14300 Lora Drive - Post Council Meeting Followup

14300 Lora Drive Architectural Design

Images Illustrate How Step-Backs and Reduction in Height & 2nd Floor Mass, Bulk, Scale Can Help

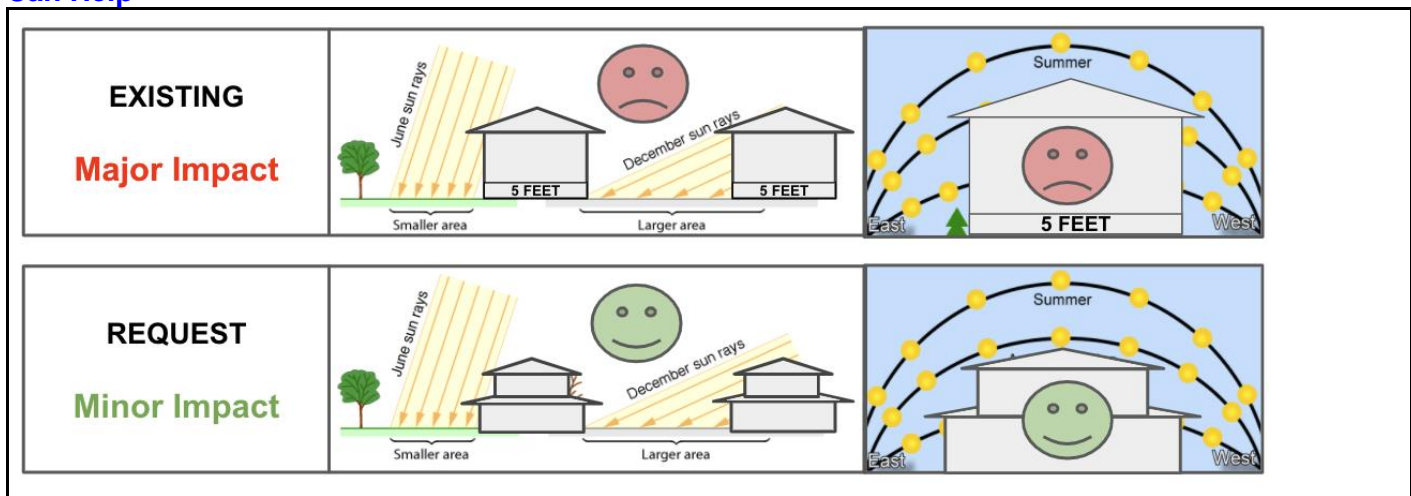
1 Mass/ Bulk/ Scale - Reduce the Height at least 4 feet w/ Attention to Left Elevation Side Wall

We are specifically seeking a reduction of the finished floor elevation as well as a reduction of the overall height, at our setback, by stepping back the second floor. Our specific concern is the height of the left elevation walls. As this seems to be indicative of Formal Mediterranean Architecture, perhaps Informal Mediterranean is more appropriate for our neighborhood.

2 Sun Exposure - Reduce Impact of Structure Blocking Access to the Sun

The provided Shadow Survey demonstrates that in December, there is total obstruction to a significant portion of our house as well as the complete coverage of our defined outdoor Active Use Areas. It is essential to minimize this impact to a more acceptable level.

The reduction of Mass/ Bulk and Scale is the only way to reduce this impact. We are not seeking complete access to the sun, but are very concerned that the planned structure will have significant impacts between November, December and January. Besides the obvious concerns with ensuring we have access to the sun, we have a specific health concern which we are asking for specific consideration.

This Images Demonstrate our Privacy Concerns

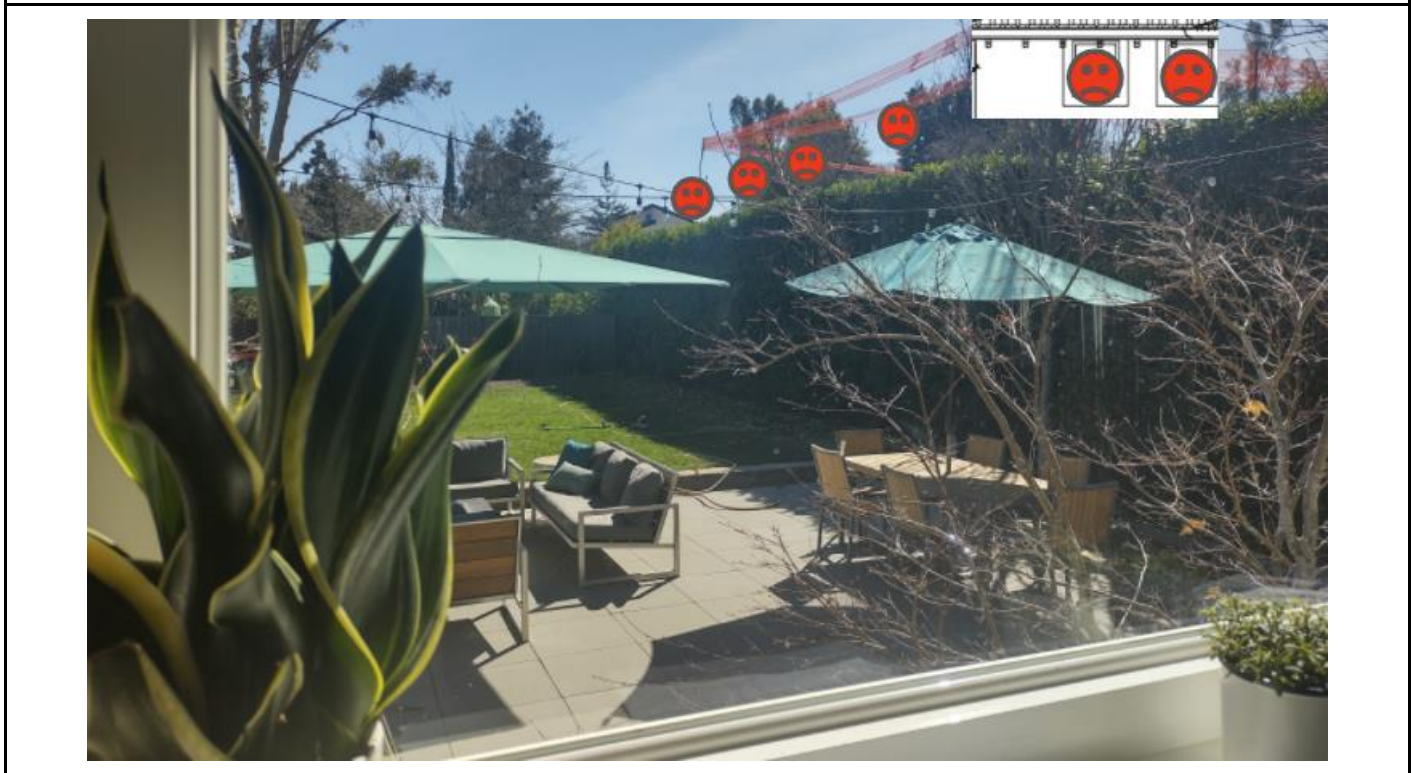
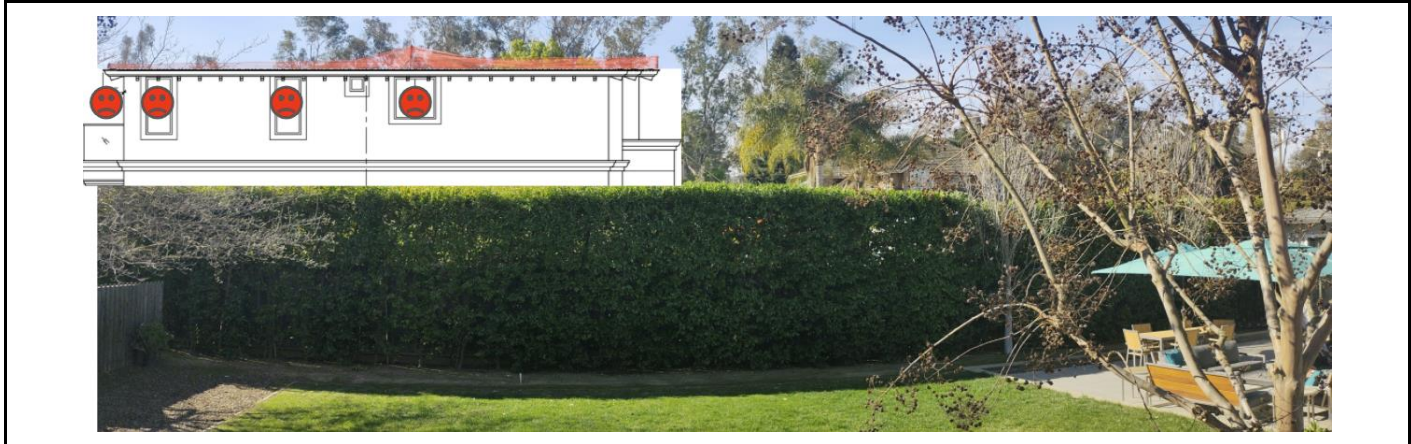
3 Establish Suitable Privacy - Reduce Impact from 2nd Story Windows

The windows on the 2nd floor provide absolute and clear visibility into our Kitchen/ Dining Area as well as provide stadium views of our complete backyard and clearly defined active use areas. The reduction of the 1st floor's finished floor height, along with the 2nd Floor Step-Back will aid tremendously with improving our privacy. Raising the window sills to 5 feet from the floor will also help this. The installation of opaque glass on bathroom windows will also improve. The balcony creates a visual vantage point, which needs to be addressed. Screen trees have been proposed, however due to the location there will be insufficient sunlight to be effective within 2 years. I would also prefer a species that would not have such a large crown which would also negatively impact our Sun Exposure.
